Inspection Photos

Loc: 484358

Operator: DESERT EAGLE OPERATING LLC

Inspection Date: 12/12/2024

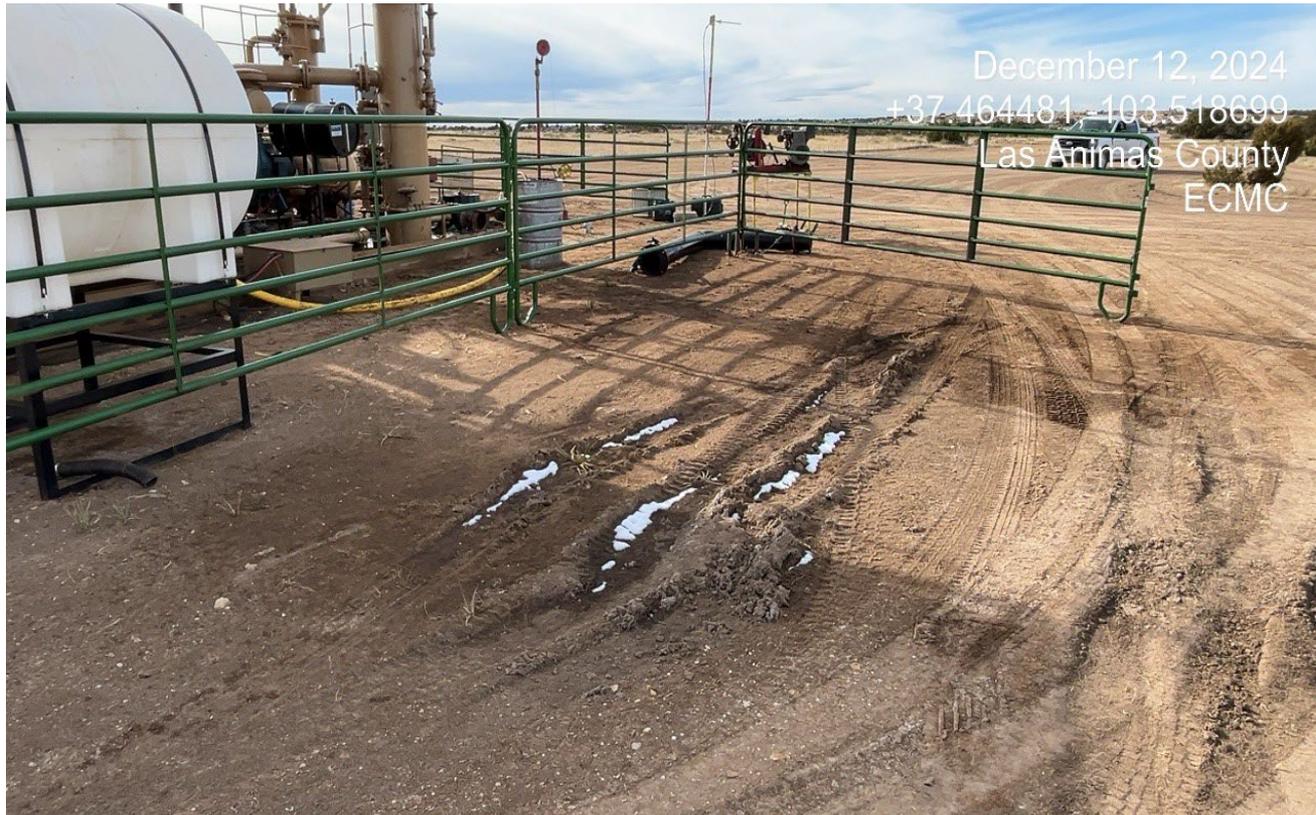
Photo 5. North side of the compressor facing west. Stained oily soils sprayed out on both side of the compressor. Vehicles are driving thru and tracking this area.
